# UNITED STATES PATENT AND TRADEMARK OFFICE

10/788,785

<b>Office Action Summary</b>	<b>Application No.</b> 10/788,785	<b>Applicant(s)</b> JOHNSON ET AL.	
	<b>Examiner</b> Adriana Figueroa	<b>Art Unit</b> 3637

**DETAILED ACTION**

*FIG. 2A*

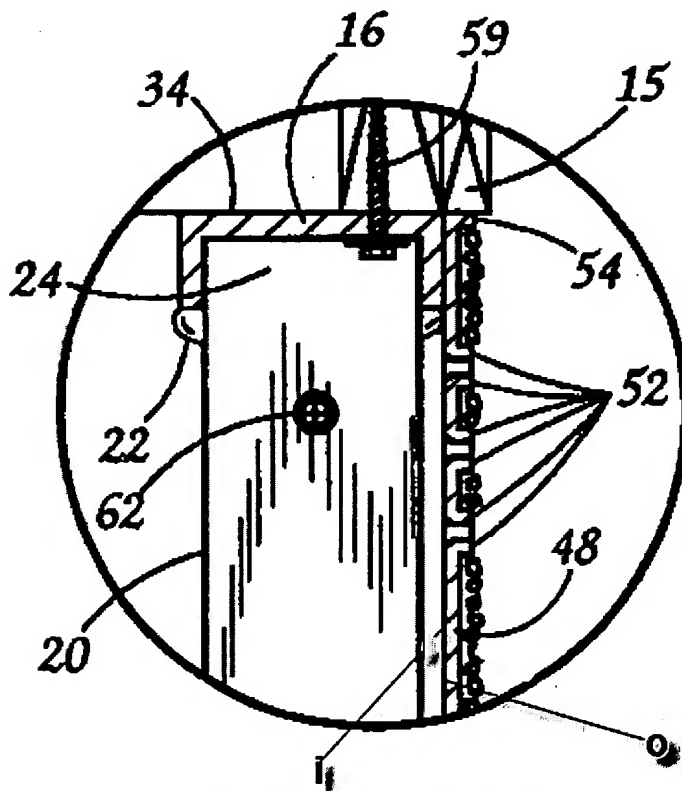
Regarding claim 1, Wolfrum discloses a panel having a member (48) comprising an outwardly-directed surface (o) to which the ornamental façade (50) is affixed, and an inwardly-directed surface (i) to which a support framework (F) is integrally coupled, (annotated Figures 2A, 4); said support framework (F) comprising a first section (16, 18, 20R, 20L) located generally along the periphery of said inwardly-directed surface (i) and at least one interconnect section (20) extending between said first section (annotated Figures 2A, 4); and a plurality of apertures (58) through a lower length (18) of said first section, each said aperture sized for accepting a fastener (60) permitting the securing of the panel to the foundation (14), (Figures 2, 3), (Column 4, Lines 16-19).

Regarding claim 5, Wolfrum modified by Barylski discloses as discussed above. Wolfrum teaches a panel having: said outwardly-directed surface (o) is generally planar and rectangular in shape, (Figure 1, annotated Figure 2A); said first section further

Regarding claim 9, Wolfrum modified by Barylski discloses as discussed in claim 1; Wolfrum teaches a panel wherein: for each of the panels said first section further comprises right-side (20R), left-side (20L), and upper (16) sections, said upper section having a plurality of apertures (58) therethrough; and said support framework (F) further

comprises a second interconnect section (20) extending between said first section, (Figure 2A, annotated Figure 4); and the panels are arranged such that said left-side section (20L) of one of said plurality of panels is secured to said right-side section (20R) of an adjacent panel, (Figure 3A) (Column 4, Lines 18-25).

Regarding claim 2, Wolfrum modified by Barylski discloses as discussed in claim 1; Wolfrum teaches a panel wherein said outwardly-directed surface (o) is generally planar and polygonal in shape, (annotated Figure 2A, Figure 4).

**FIG. 4**

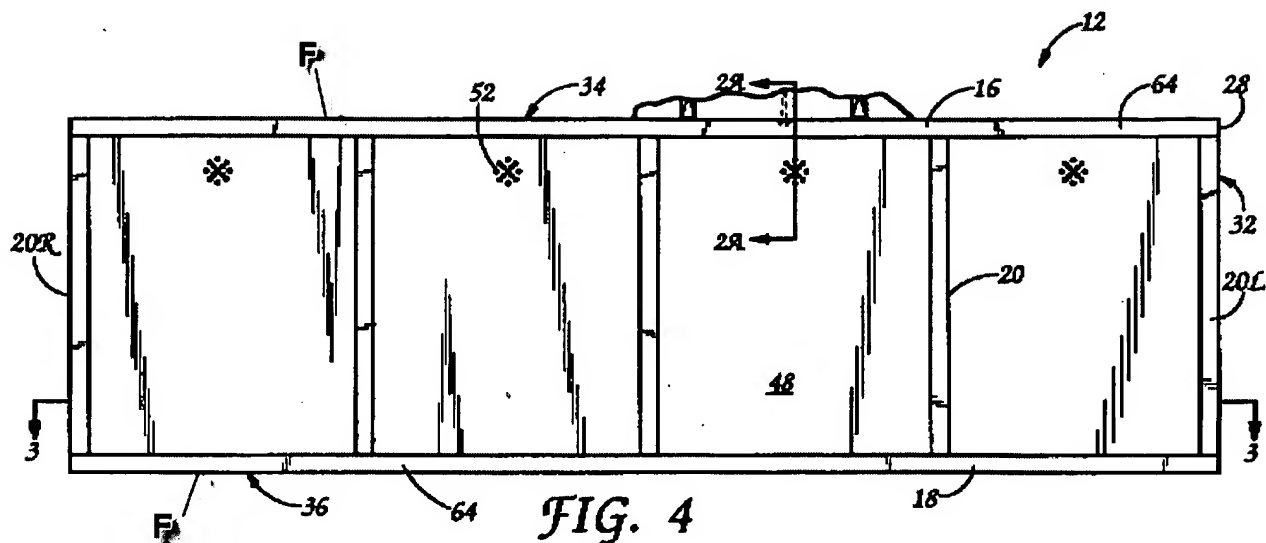
Regarding claim 10, Wolfrum discloses a panel having an ornamental facade (50) and capable of securing to a foundation (14), the panel comprising: a member comprising an outwardly-directed surface (o) to which the ornamental facade is affixed, and an inwardly-directed surface (50) to which a support framework (F) and right (20R) and left (20L) vertical supports are coupled, (annotated Figures 2, 4) said support framework (F) comprising a first section (16) located generally along a top periphery of said inwardly-directed surface (i) (annotated Figure 4); (c) each said right (20R) and left (20L) vertical support comprising an angle iron shaped extension, a top-end (t) and lower-end (l) of which has a respective ledge permanently affixed, (annotated Figures 2, 4). Wolfrum does not disclose the support framework being plastic. However, Barylki teaches a support framework (11) made of plastic, (Figure 1), (Column 2, Lines 32-35). Therefore, it would have been obvious to a person having ordinary skill in the arts at the time of the applicant's invention to modify the support framework of Wolfrum to be made of plastic as taught by Barylki in order to provide a lightweight, and rust resistant structure.

Wolfrum modified by Barylski, Hasecke and Hazan disclose said support framework (F) and said plastic member (48) are integrally fabricated, (annotated Figure 4).

Wolfrum modified by Barylski, Hasecke and Hazan discloses said support framework (F) and said plastic member (48) are integrally fabricated, (annotated Figure 4).

FIG 3

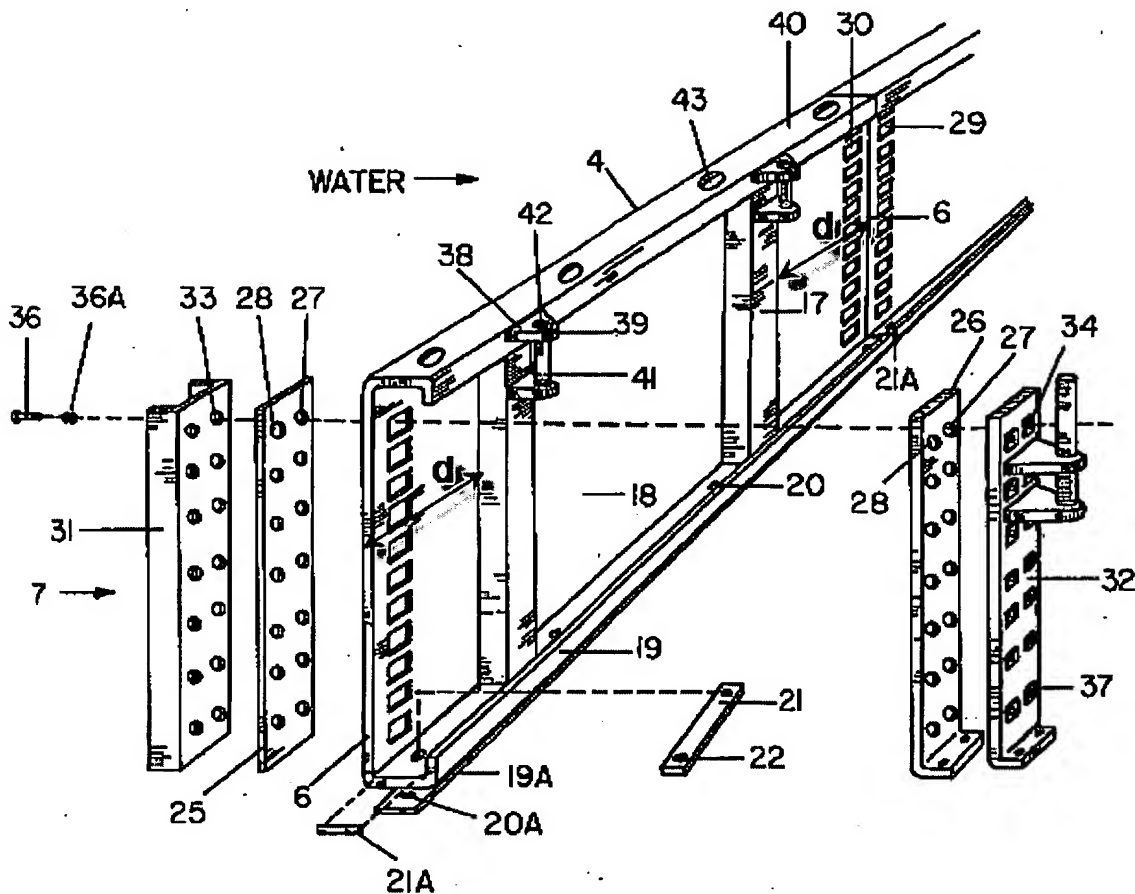
15. Claim 15 is rejected under 35 U.S.C. 103(a) as being unpatentable over Wolfrum (US 6,205,720) in view of Barylski (US 4,214,412) and further in view of Clark (US 4,375,929). Wolfrum modified by Barylski discloses as discussed in claim 14 but does not disclose a panel having said first section further comprising right-side and left-side sections coupled to said inwardly-directed surface a distance from a respective right and left periphery of said inwardly-directed surface. However, Clark teaches a panel (4) having said first section further comprising right-side and left-side sections (17) coupled

to said inwardly-directed surface (18) a distance (d) from a respective right and left periphery (6) of said inwardly-directed surface, (annotated Figure 3). Therefore, it would have been obvious to a person having ordinary skill in the arts at the time of the applicant's invention to modify the panel of Wolfrum and Barylski to include right-side and left-side sections coupled to said inwardly-directed surface as taught by Clark in order to provide a stronger panel.

The modified panel of Wolfrum, Barylski and Clark will have the right vertical support (20R) coupled to said inwardly-directed surface (i) within said distance (d) from

said respective right periphery.
